PROPOSED VILLAGE OF EDEN OAK

BUILDING B SHELL
 INTERSECTION OF MARINA DRIVE, LANDMARK DRIVE & OAK HARBOR BOULEVARD
 PARCEL 14-1 OAK HARBOR
 SECTION 27 & 34, T-9-S R-14-E
 SLIDELL, LOUISIANA 70458
 ST. TAMMANY PARISH
 THIS PROJECT IS NOT FOR OCCUPANCY

This is in response to the comments received on August 14, 2025, regarding a commercial development at Parcel 14-1 in Oak Harbor Subdivision. The comments were addressed by the following:

EXHIBIT 1
(SHEET 1 OF 2)

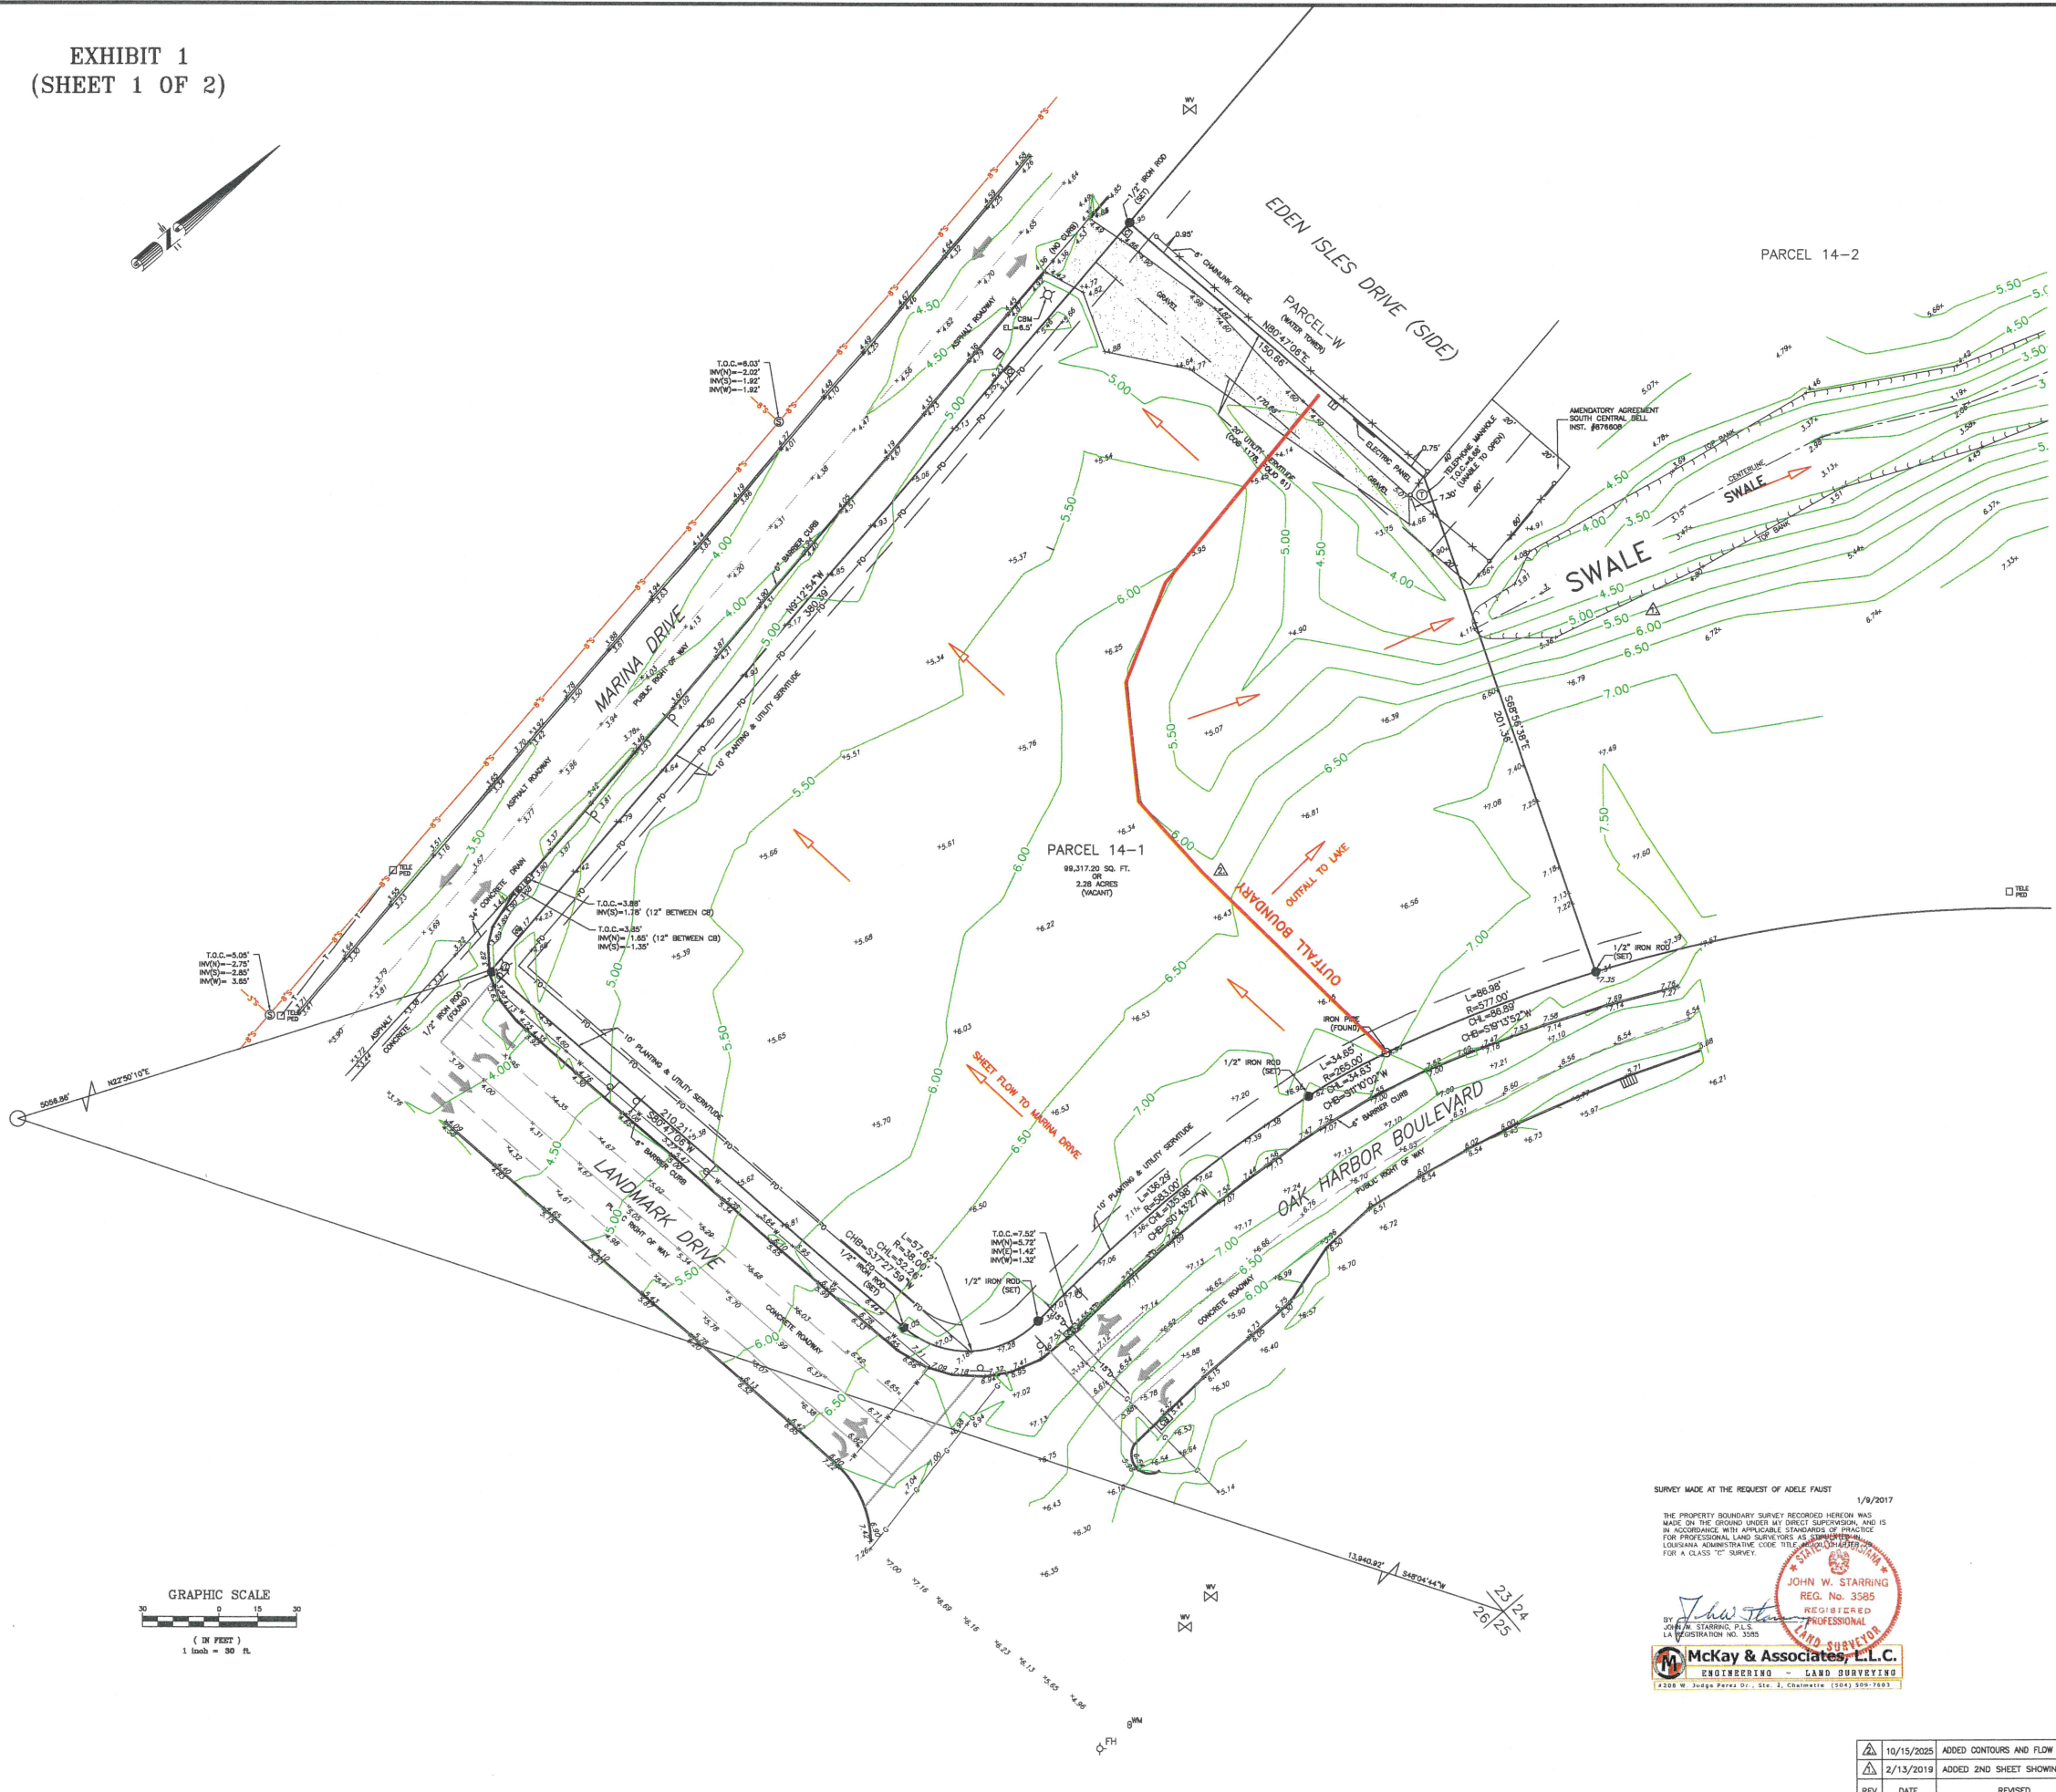
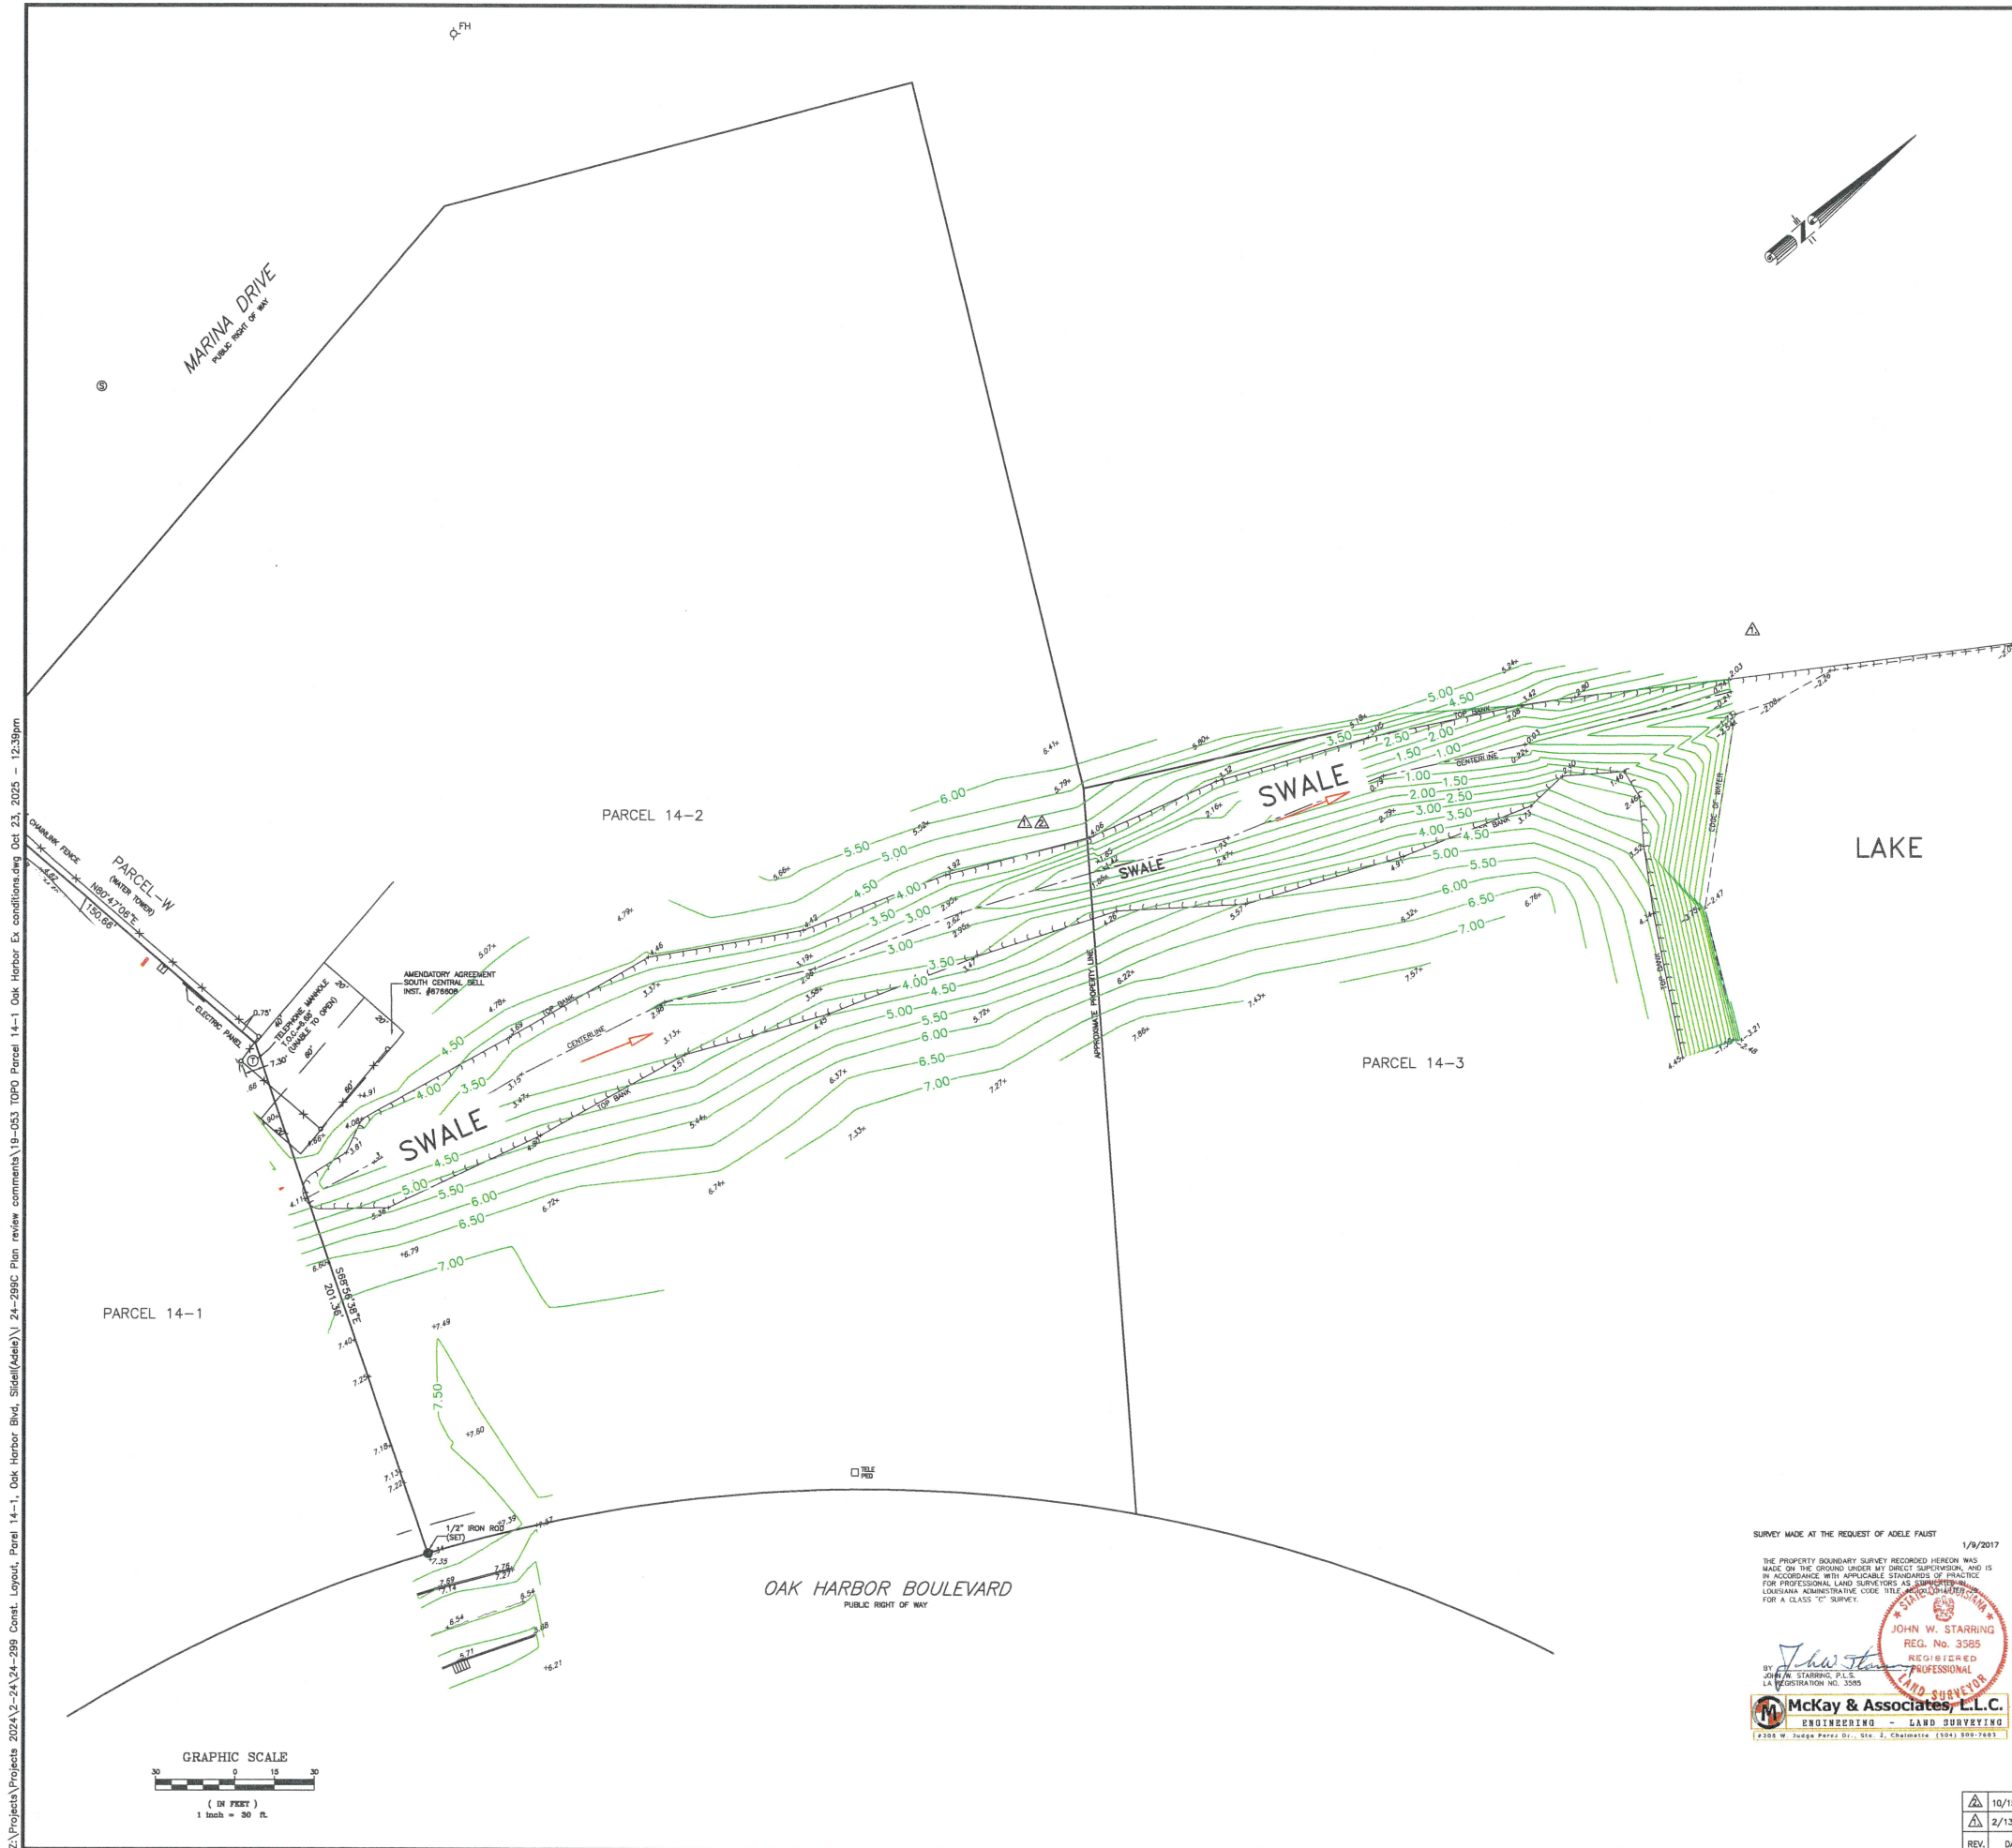
1. Drainage comment – Provide a pre-development drainage plan (existing conditions).
 - a. Refer to Exhibit No. 1 (two sheets), Topographic survey of Parcel 14-1, dated 1/9/2017, revised to include the drainage patterns and contour lines which show the majority of runoff sheet-flows west towards Marina Drive, except a portion which flows through a swale north to a lake.

2. Drainage comment – Confirm neighboring lots are not draining into proposed development as it cannot interfere or block existing drainage patterns.
 - a. Refer to Exhibit No. 1 (two sheets), Topographic survey of Parcel 14-1, dated 1/9/2017, which shows that runoff from the adjacent property flows north, away from the proposed development through a swale to a lake.
